PROPOSED AMENDMENTS FROM PREVIOUS APPROVED SIGNAGE APPLICATION

Project CINEWORLD BARNLEY

Drawing PROPOSED EXTERNAL SIGNAGE

Drawing No. 1722\BA-019 Revision M

ELEVATION A

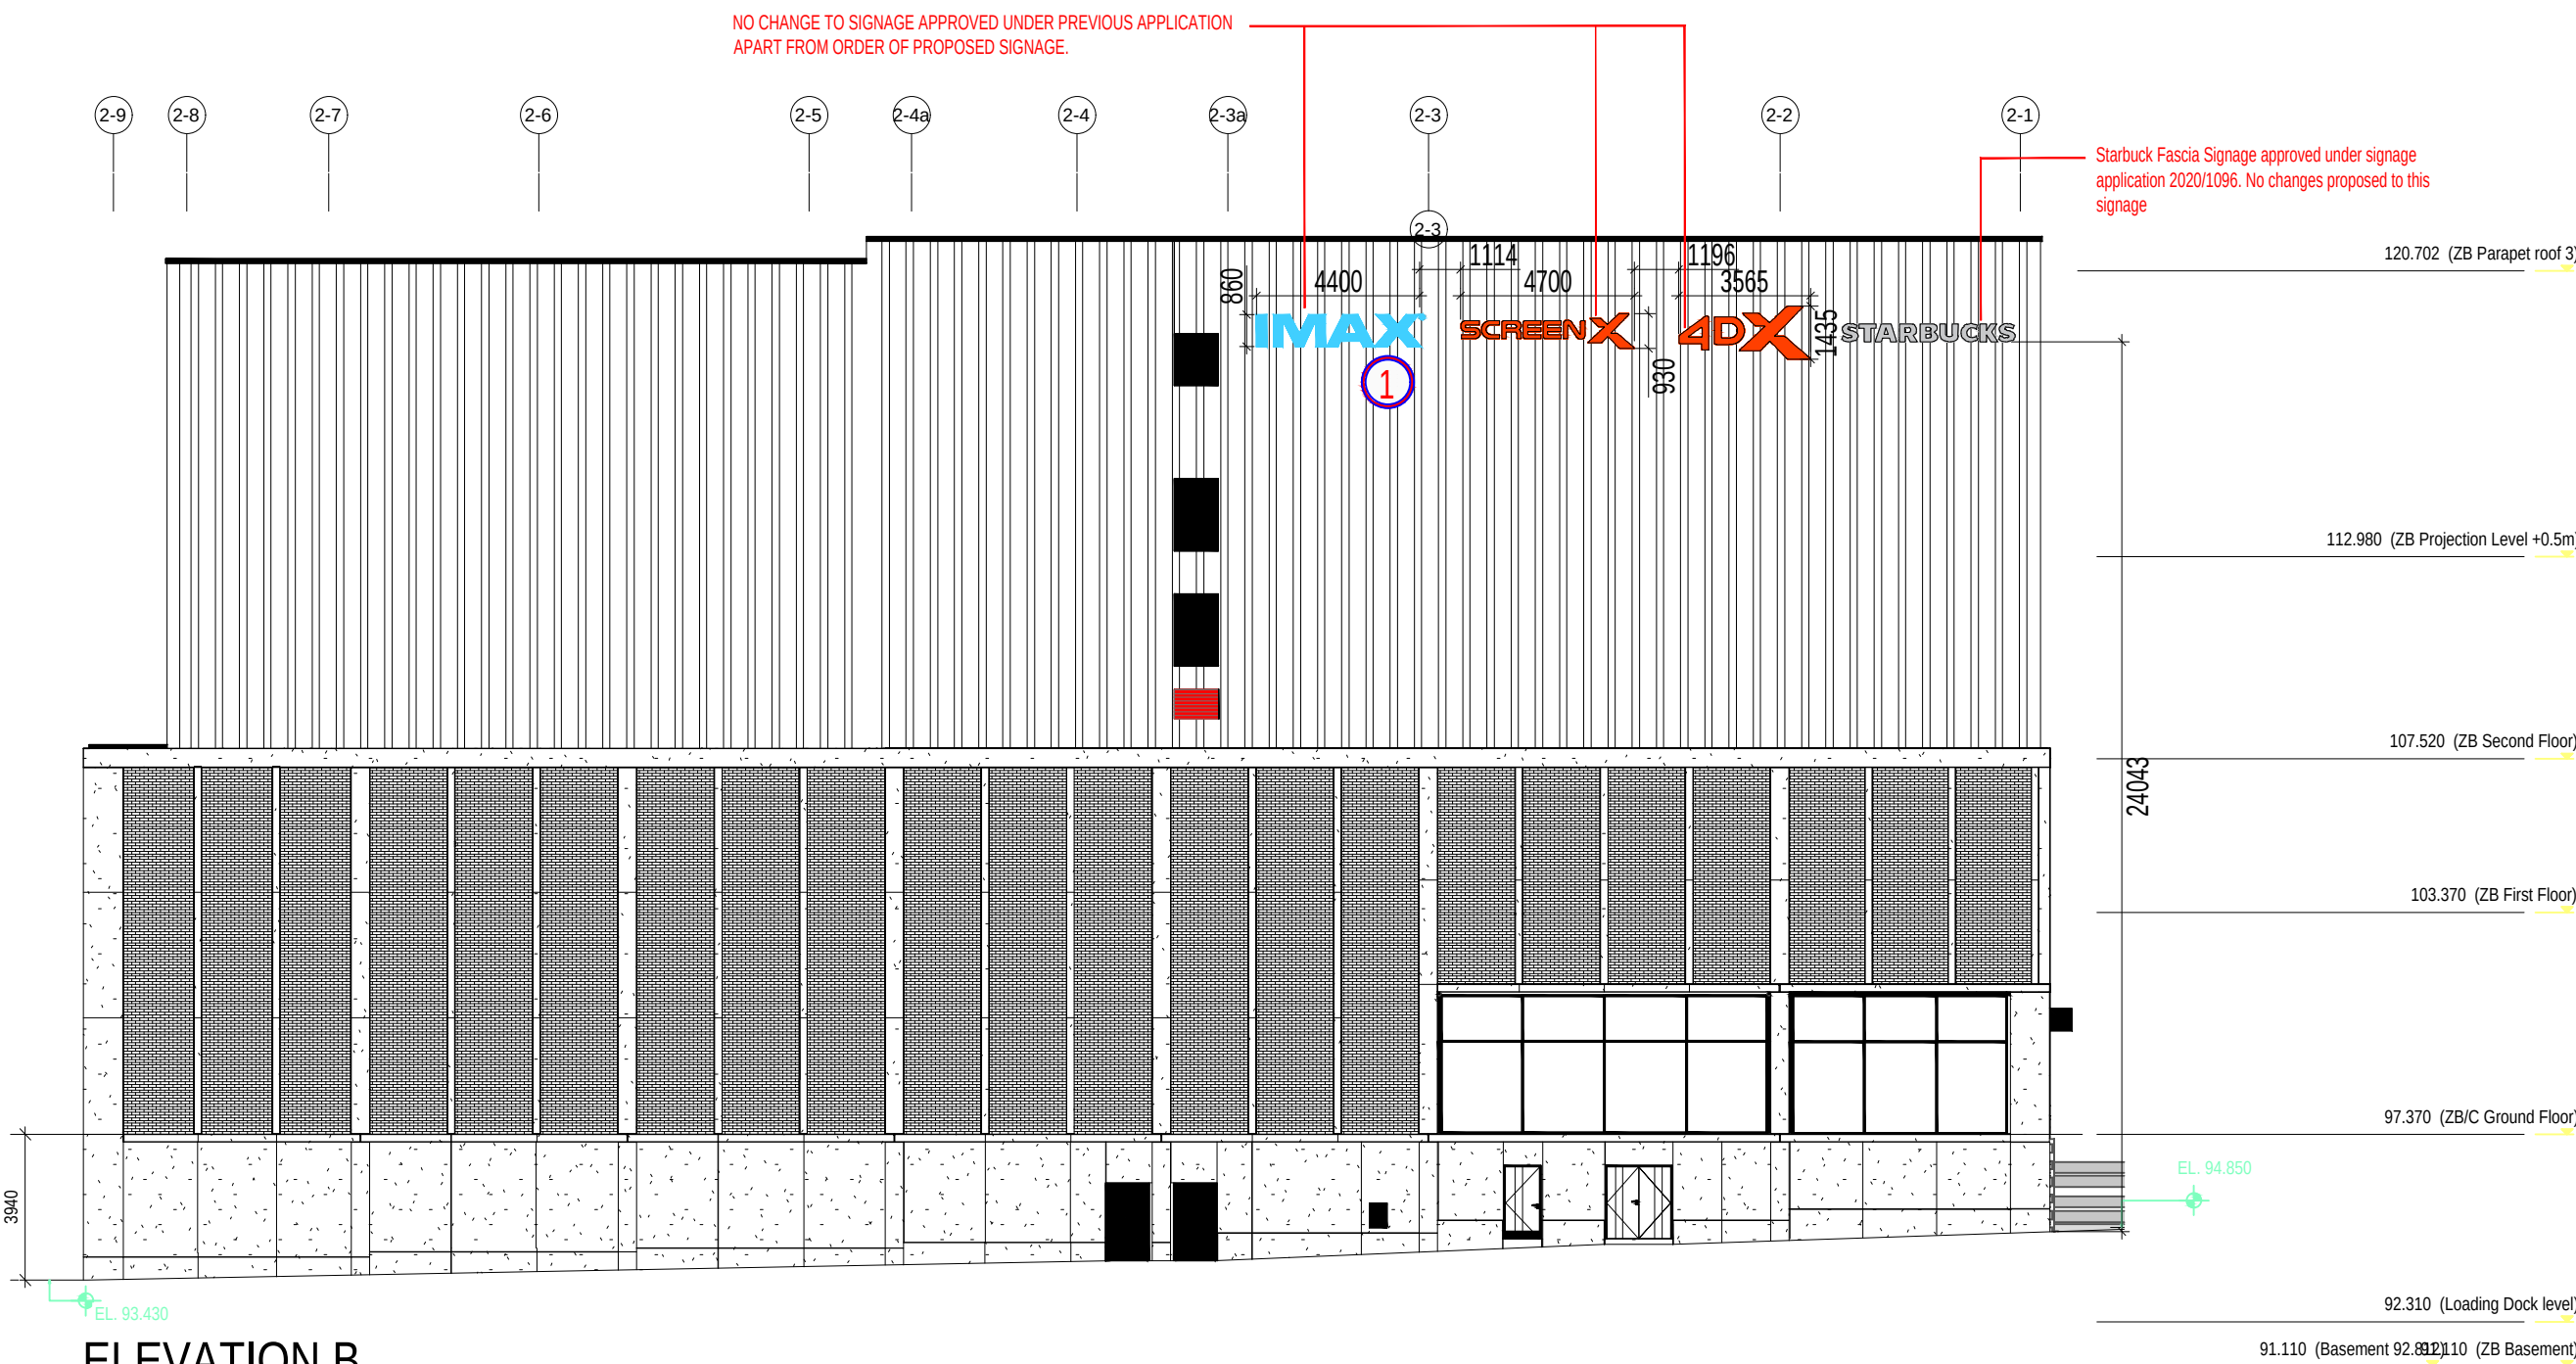
1. Proposed signage order altered - approved signage order SCREEN X, 4DX, IMAX. Proposed order IMAX, SCREEN X, 4DX
2. Proposed signage order altered - approved signage order SCREEN X, 4DX, IMAX, STARBUCKS. Proposed order IMAX, SCREEN X, 4DX, STARBUCKS.

3. Cineworld signage previously approved as internally hung behind glazing. New proposal is for the the signage to be externally mounted on steel rails directly infront of the mullions, rails to be powder coated to match existing mullion colour. Please refer to Section B for further information.

4. SCREEN X, 4DX & IMAX signage previously approved as internally hung behind glazing. New proposal is for the the signage to be externally to existing fixing points in the external mullions. Signage to be hung as per detail in Section B.

5. STARBUCKS signage previously approved as internally hung behind glazing. New proposal is for the the signage to be externally mounted on existing fixing locations in external mullions. Signage to be hung as per detail in Section B.

6. New Starbucks illuminated projecting signage to be installed on column.
7. New illuminated Cineworld Star to be mounted on external column.
8. Existing vinyl internally applied to hide structure and void to be retained.

9. New starbucks logo illuminated sign - to be internally hung.

SECTION B

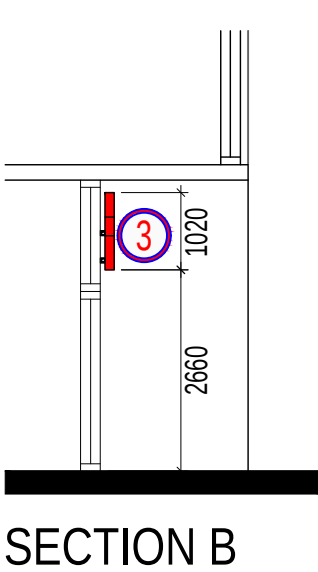
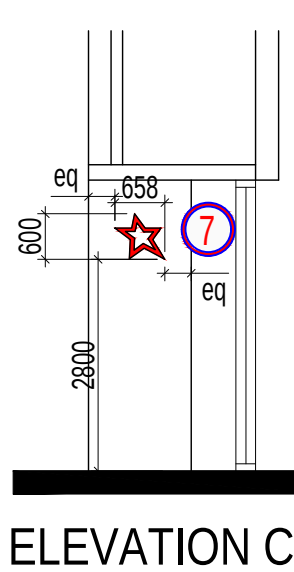
SIGNAGE PREVIOUSLY APPROVED AS BEING INTERNALLY FIXED UNDER SIGNAGE APPLICATION 2020/1096 - SIGNAGE NOW TO BE EXTERNALLY HUNG AND TO AND MOUNTED ON EXISTING FIXING LOCATIONS IN THE MULLIONS.
